| Product hierarchy no. * |     |     |            | Part no.       | SBU                | Type / Description | Customer part no. |
|-------------------------|-----|-----|------------|----------------|--------------------|--------------------|-------------------|
| 02                      | 005 | 016 | 0000001206 | See list below | Power entry module | 1064               |                   |

| Product Change Notification |               |              |             |                 |     |        | 1064 Power Entry Module |  |
| owner                       | creation date | release date | released by | change order no | rev | page   | D10-034-452             |  |

| Old product approval UR, CSA  | New product approval cURus  |

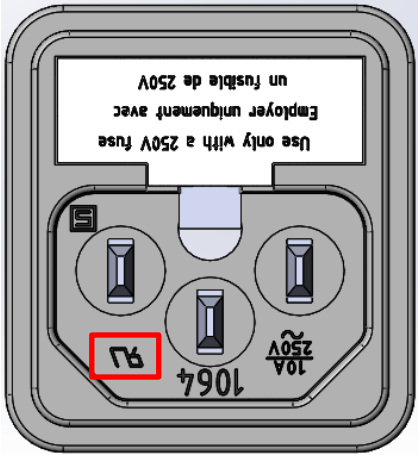
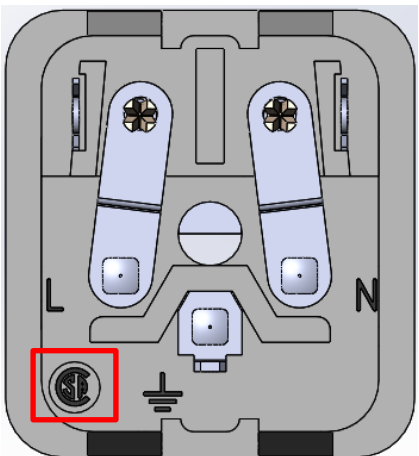
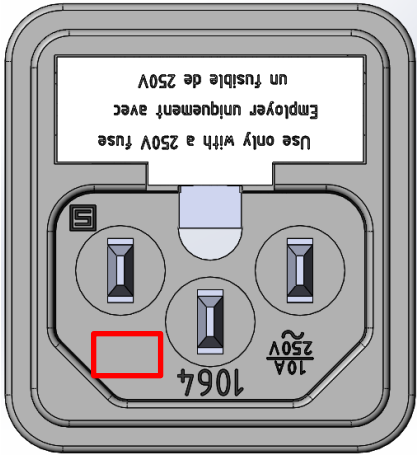
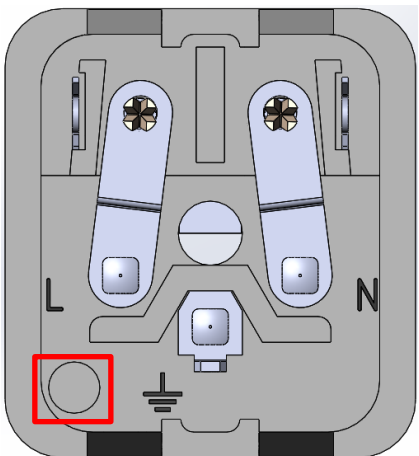
- Change of approval marks on the product.
- Modified label.

- Standards update according to the new UL/CSA 60320-1.
- Approvals new on the Label
